Addendum to System Impact Assessment Report

Project: *Kirkland Lake GS – New Generating Unit G6*

Applicant: *Northland Power Inc.*

CAA ID 2000-009

Figure 3. Generator Capability Curve

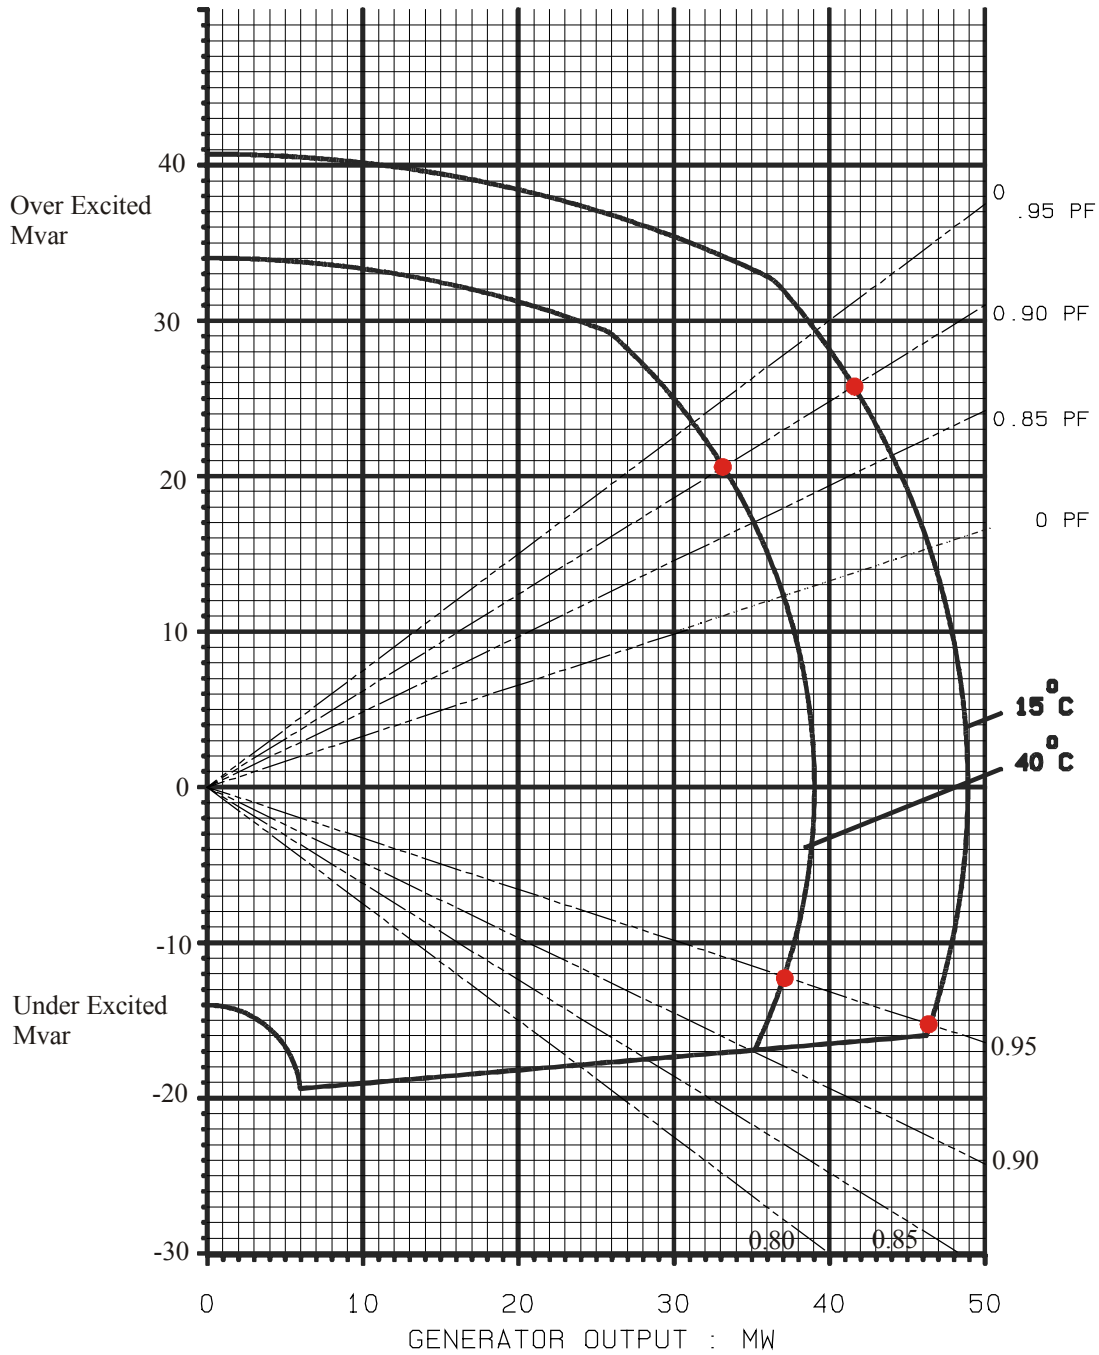
The Market Rules require that each synchronous facility connected to the IMO-Controlled Grid have the capability to supply reactive power within the range between 90% lagging (overexcited) and 95% leading (underexcited) power factor based on rated active power at rated voltage. The generator Reactive Capability Curves, shown in Figure 3 provided by the applicant indicate that, at rated active power output (44 MW) the unit is capable of absorbing 16 Mvar or producing about 21 Mvar.

This capability meets the Market Rules requirements with respect to the reactive power absorbing capability.

It should be noted that the base field current that was submitted in the data sheets (326 A) does not match the open circuit characteristic. Using the air gap line for the calculation of the base field current, results in the base rotor current being 295 A. The corresponding base field voltage should be 30.8 V.

FIGURE 4. Exciter and Stabilizer Models for Kirkland Lake G6

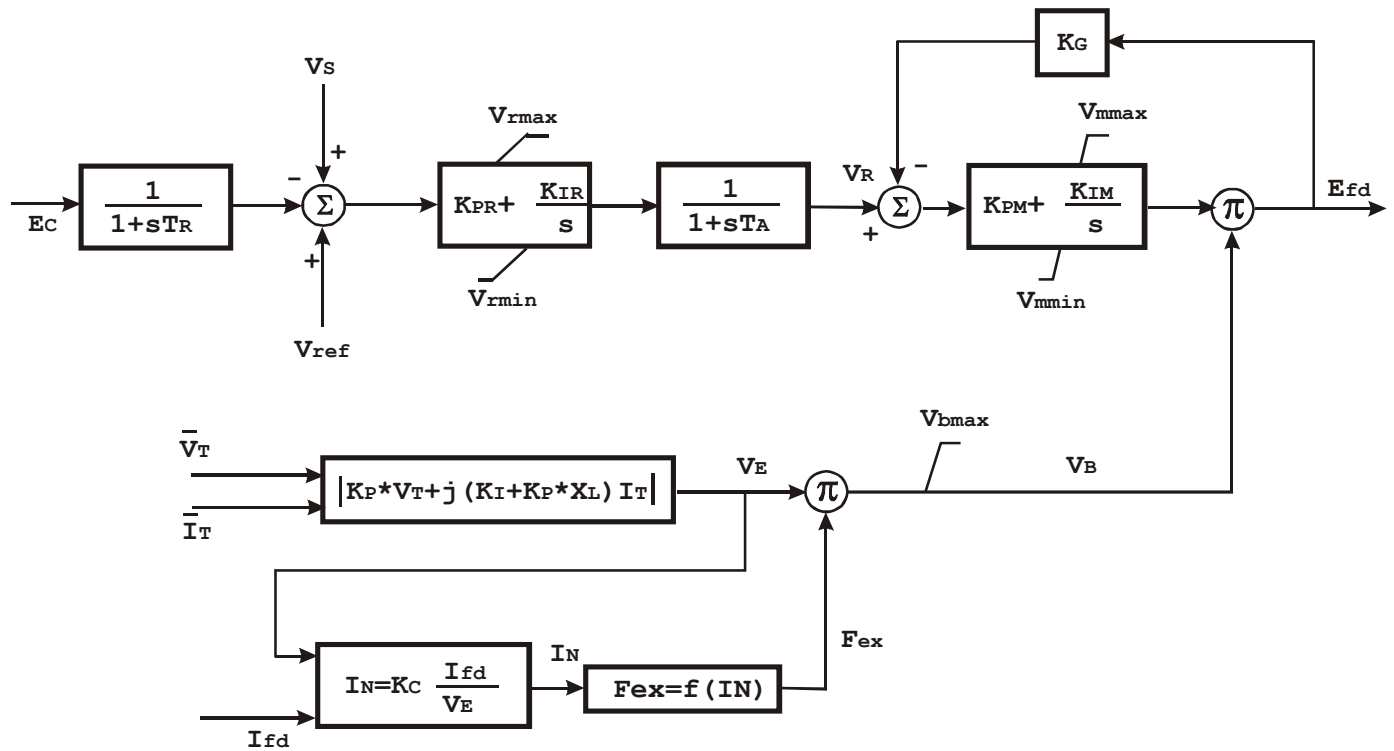
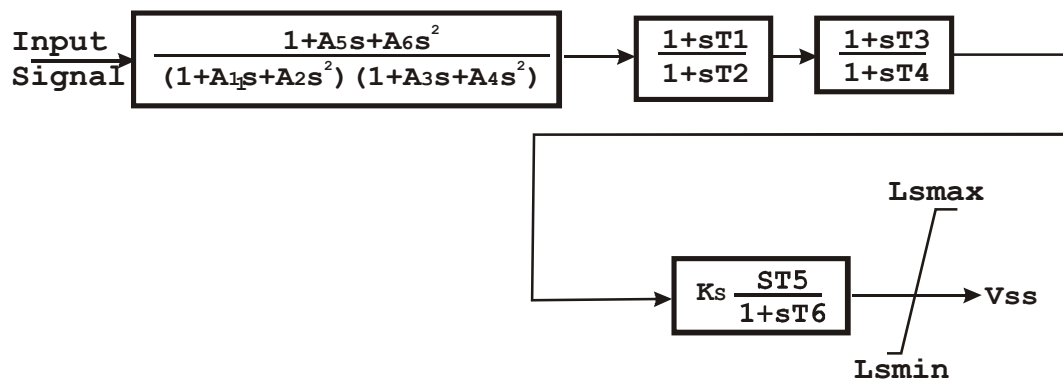
The information provided by Northland Power Inc. was in part incomplete because some of the data required to fully assess the performance characteristics of the generator controls were missing. Northland Power provided a model for a commonly used static excitation system proposed for installation with the new generating unit. The information included detailed block diagrams for the exciter but lacked the stabilizer model and the actual data for both exciter and stabilizer. However, for this type of excitation system the IMO was able to provide a model and parameters which lie in a typical and acceptable range, and study the performance of the new generating unit.

The exciter and stabilizer models and data selected by the IMO are shown in Figure 4. They are composed of a type ST4B static exciter and IEEEEST type stabilizer.

The rated rotor current is calculated (from the generator's V curves) to be 740 A at 31.2 MW output and 0.9 power factor lagging. Based on this value the ceiling voltage (twice the rated field voltage) should be 5.02 pu ($740 \times 2 / 295$). Hence V_{rmax} for the exciter was set to 5.2.

- A power system stabilizer be installed with the excitation system;
- Commissioning test results must be submitted to the IMO as part of the Facility Registration process, and confirm that the installed excitation system exhibits similar performance to the model that was studied and meets the market rules requirements.

FIGURE 5. Kirkland Lake G6 - Exciter and Governor Response

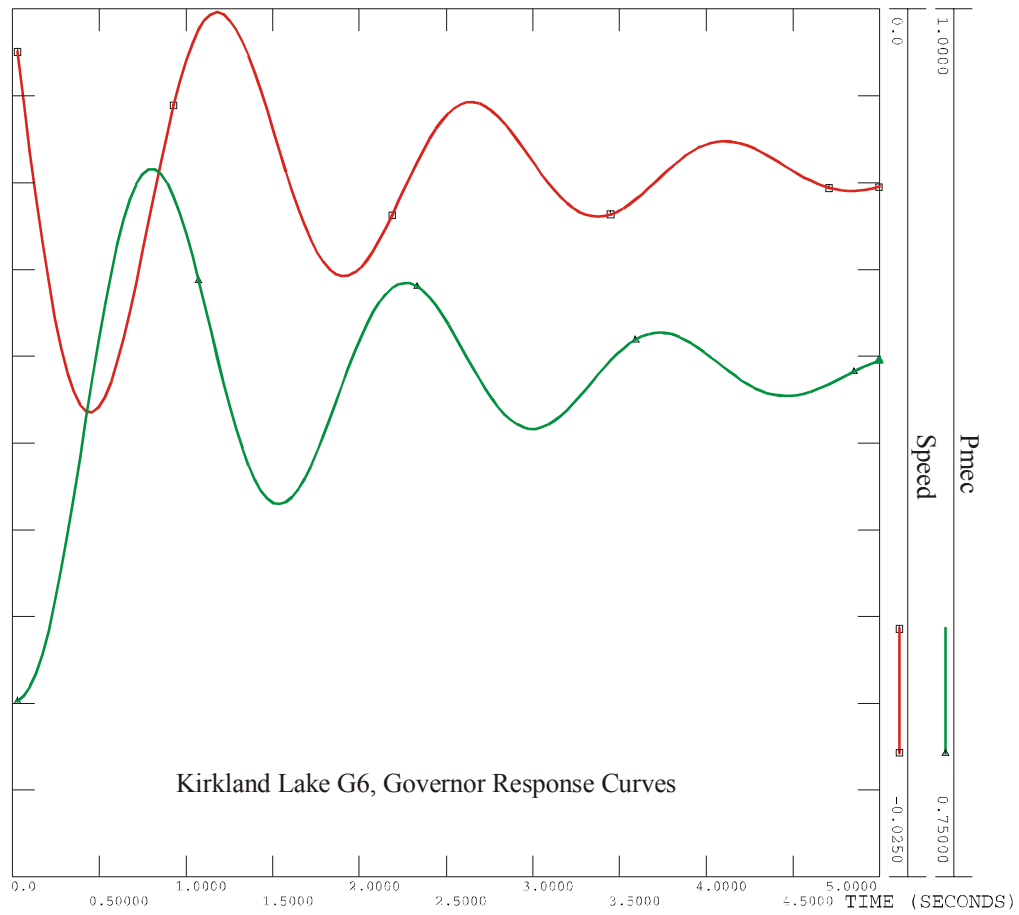
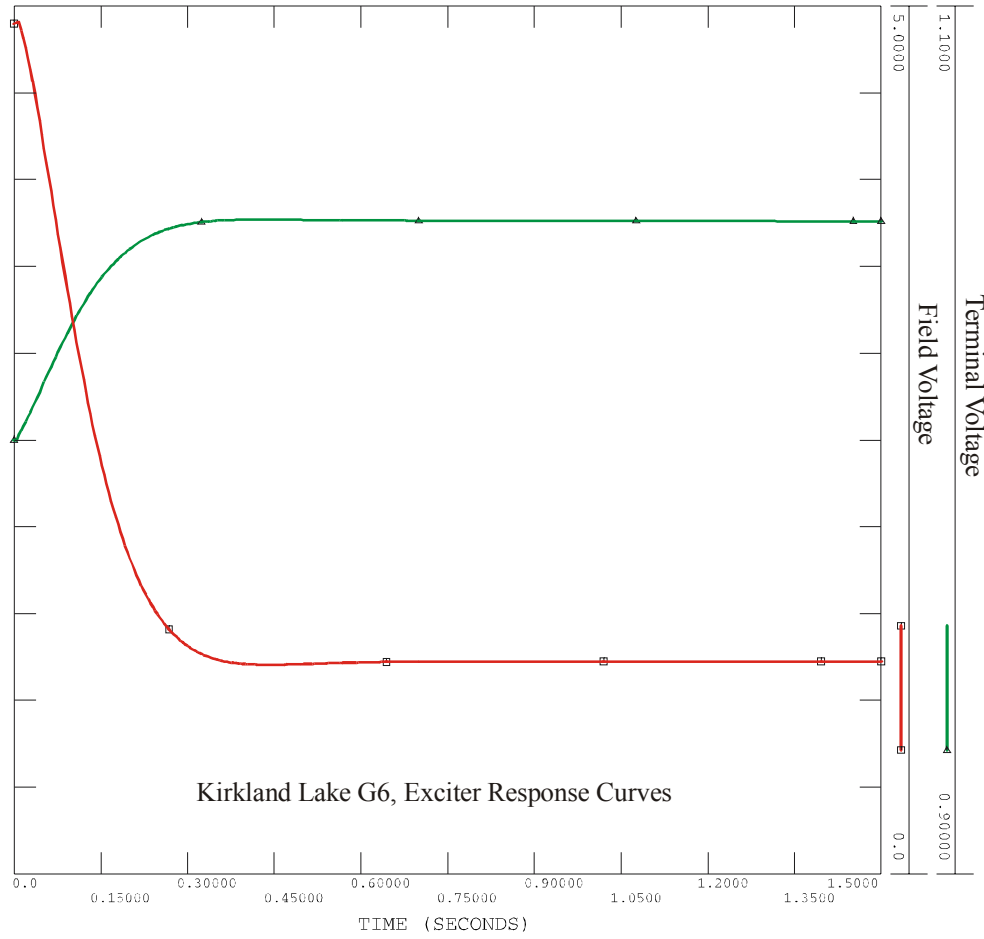
assumed excitation system meets these requirements. The results of the exciter system voltage response test to a 5% step change in terminal voltage are displayed in Figure 5. Examination of the plots indicate that:

- the exciter field voltage reaches 95% of the excitation ceiling voltage instantaneously (less than 50 ms) thus meeting the above-mentioned requirements,
- the exciter ceiling voltage meets the Market Rules requirements and
- the proposed exciter provides adequate damping of system oscillations.

Dynamic simulations were performed to verify the transient response of the governor in isolation of the rest of the system, to a load step change of 10%. The results are displayed in Figure 5. Examination of the plots indicates that the governor response is well damped.

The IMO requires that commissioning test results must be submitted as part of the Facility Registration process, to confirm that the installed governor system exhibits similar performance to the model that was studied and meets the market rules requirements.

Figure 6. Line to Ground Fault on W71D at Widdifield

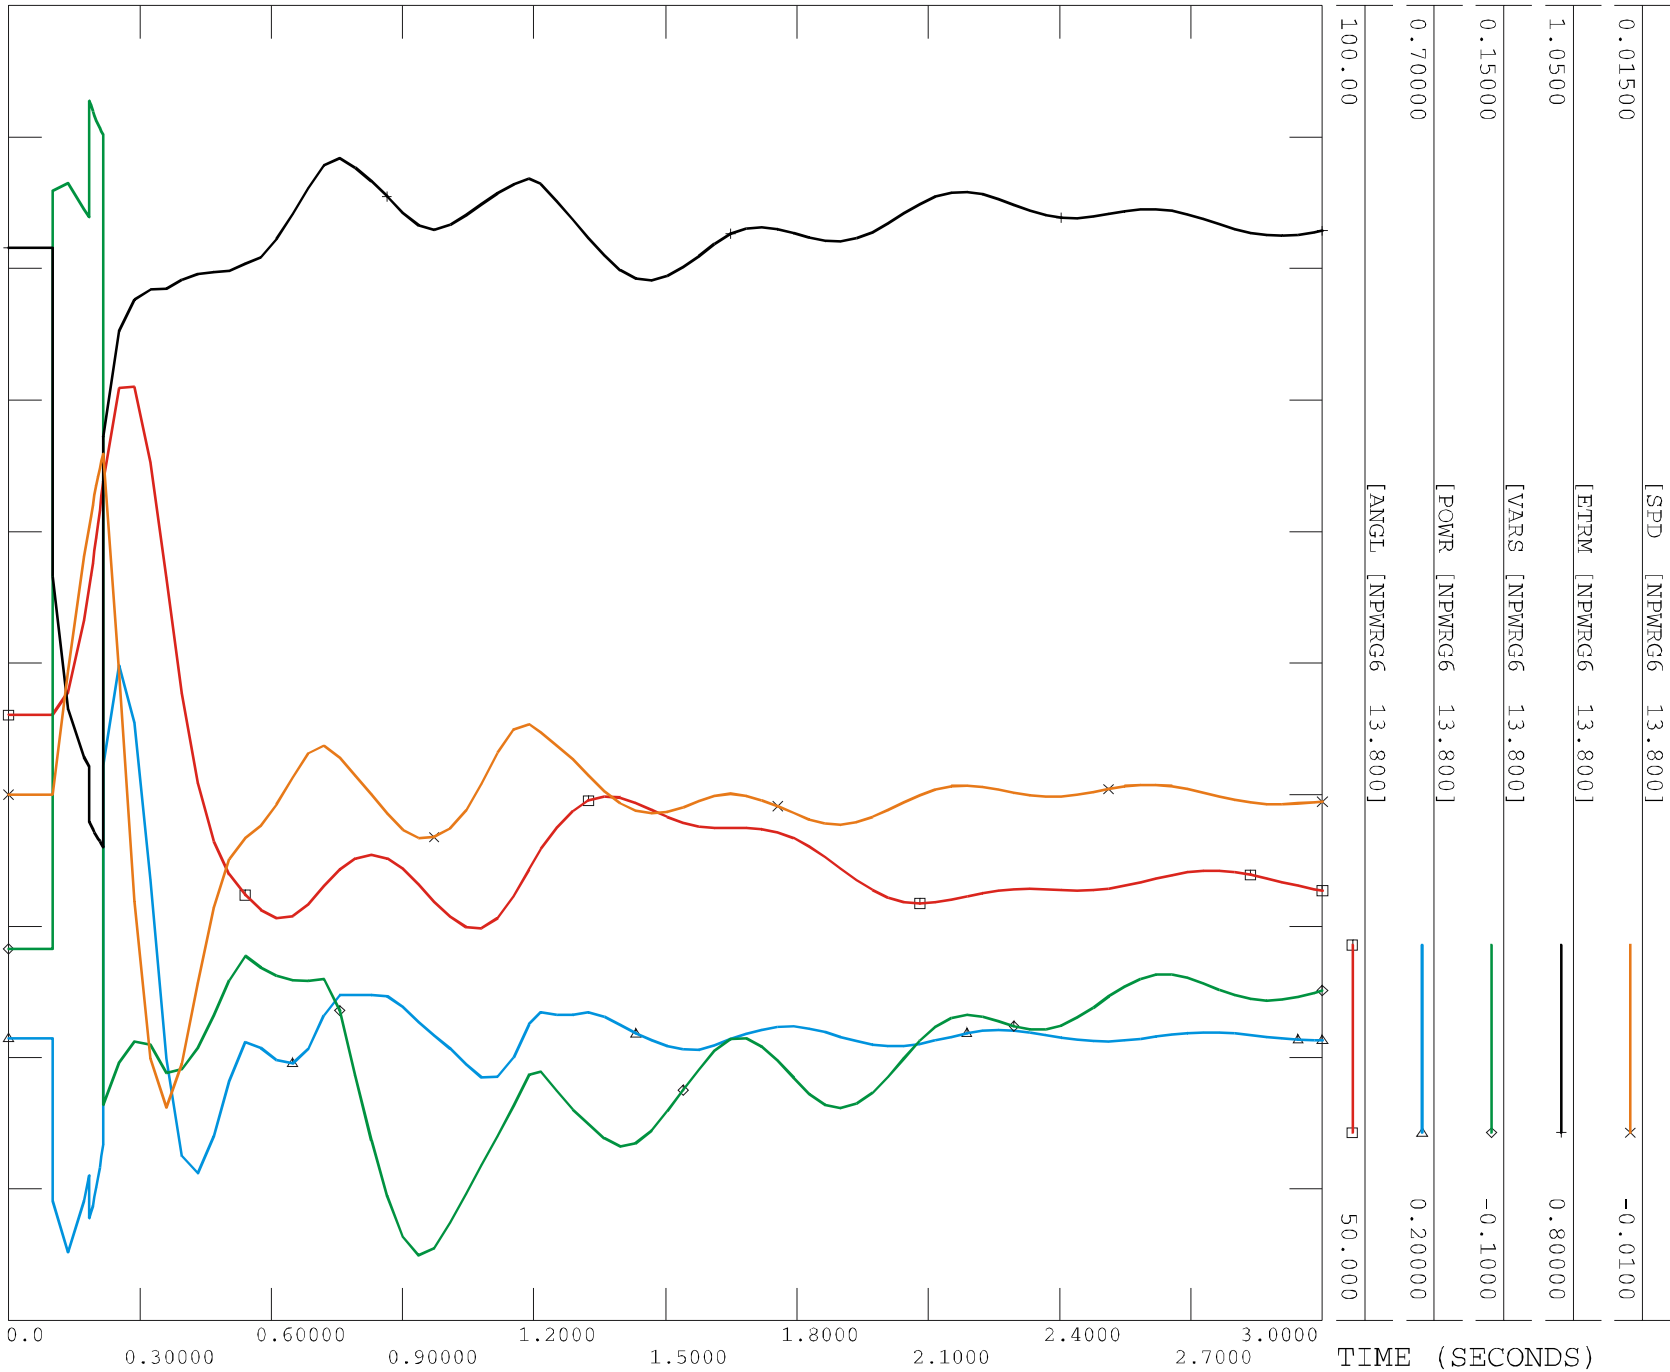
Analysis was performed to ensure that the increased output at Kirkland Lake GS will not result in system instability for a contingency involving the 230 kV circuit W71D from Dryden to Widdifield.

Simulations attempted to replicate real system operating procedure as described in section 5 of the SIA report. To achieve levels of maximum power flow south most of the generation in the northeastern Ontario was simulated at full output and Lower Notch GS was also in service.

The transient analysis plots show that the system will remain stable for a contingency involving with the 230 kV line. Plots of quantities associated with the new unit G6 are shown in Figure 6.

Figure 1. Kirland Lake Area Transmission

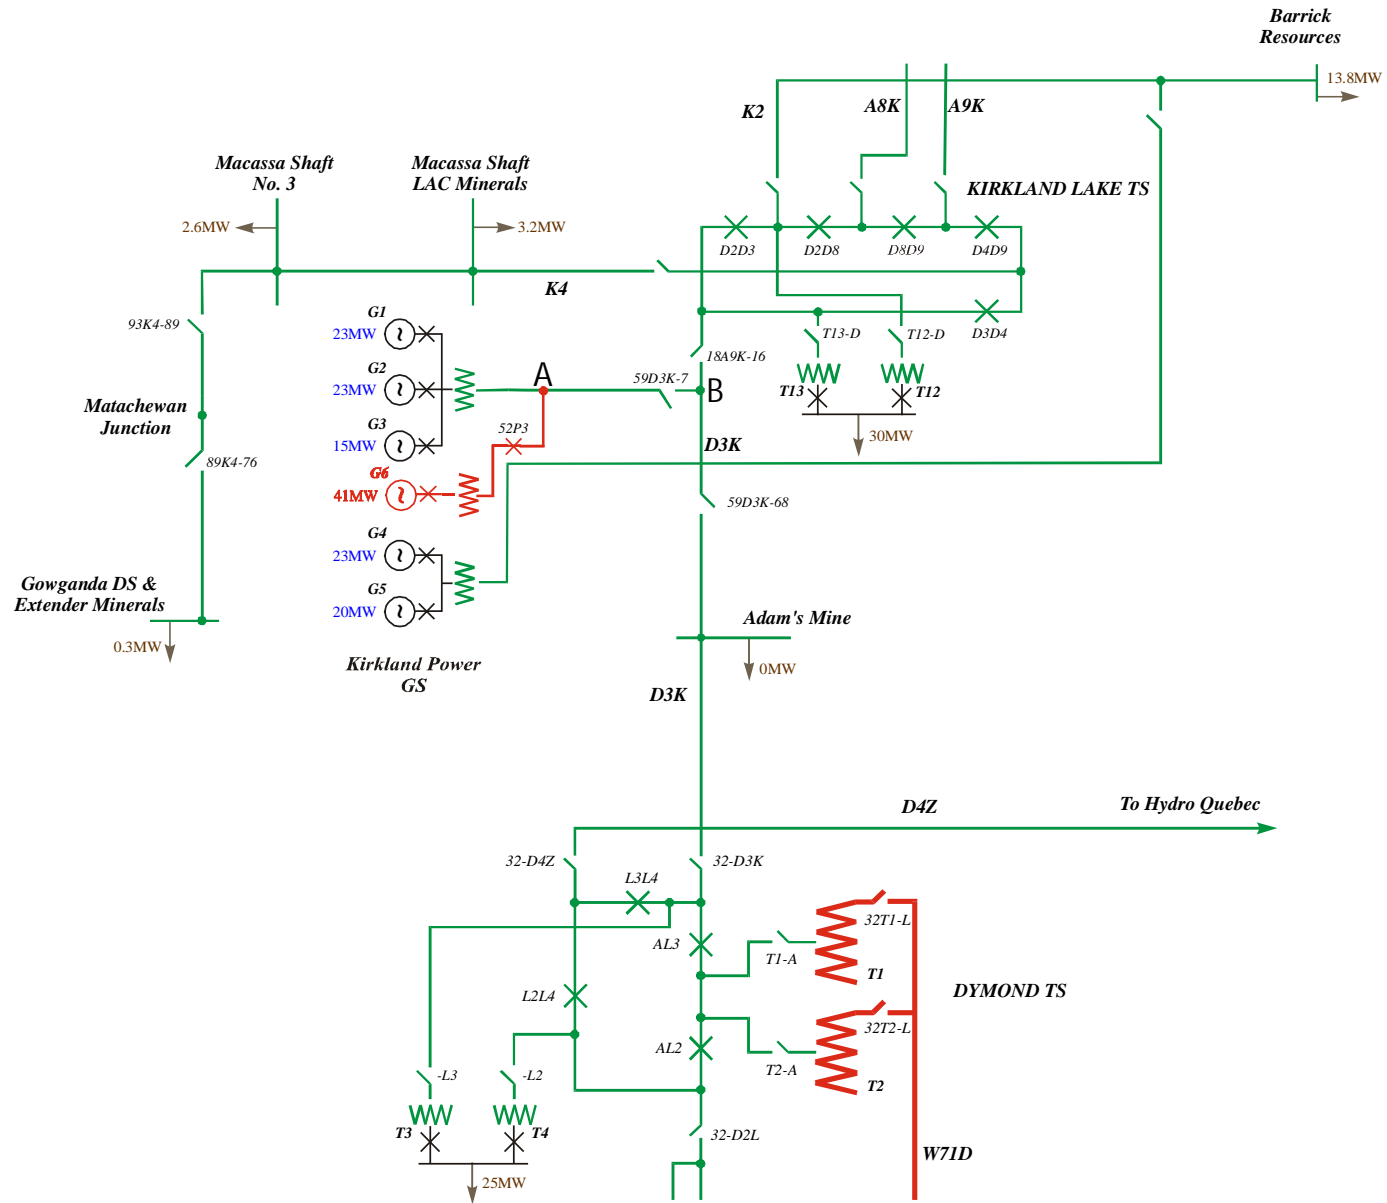
Physically, the new unit (G6) can be connected to the 115 kV circuit from Kirkland Lake to Dymond (D3K) or to the 115 radial connection of Kirkland Lake TS (K2). However, the continuous current carrying capability of K2 is insufficient to accommodate the net increase of 41 MW of power flowing into Kirkland Lake TS.

Thus, it is recommended that the new unit be connected to D3K via the existing 2 km of 115 kV line (shown in Figure 1 between points A and B), which presently connects the existing G1, G2 and G3. The new unit will be connected via a low voltage breaker, a step-up transformer (138-13.8 kV) rated at 85 MVA and a high voltage breaker, which was designated as 52P3 in the single line diagram that was provided by Northland Power (1245XE01). A short tap will be built from the 52P3 breaker to the 2 km line connecting to D3K. This 2 km line is equipped with 477 MCM, ACSR conductor. Hydro One has informed us that the line sag clearance corresponds to an operating temperature of 82⁰C. Based on this information the line continuous rating is 110 MVA and 133 MVA for the summer and winter, respectively. The continuous line rating is sufficient to accommodate the maximum output of the four units (G1, G2, G3 and G6).

The IMO requires that the new unit be connected to D3K via the existing 2 km of 115 kV circuit which presently connects the existing G1, G2 and G3. The new unit will be connected via a low voltage breaker, a step-up transformer (13.8 / 138kV) rated at 85 MVA and a high voltage breaker.
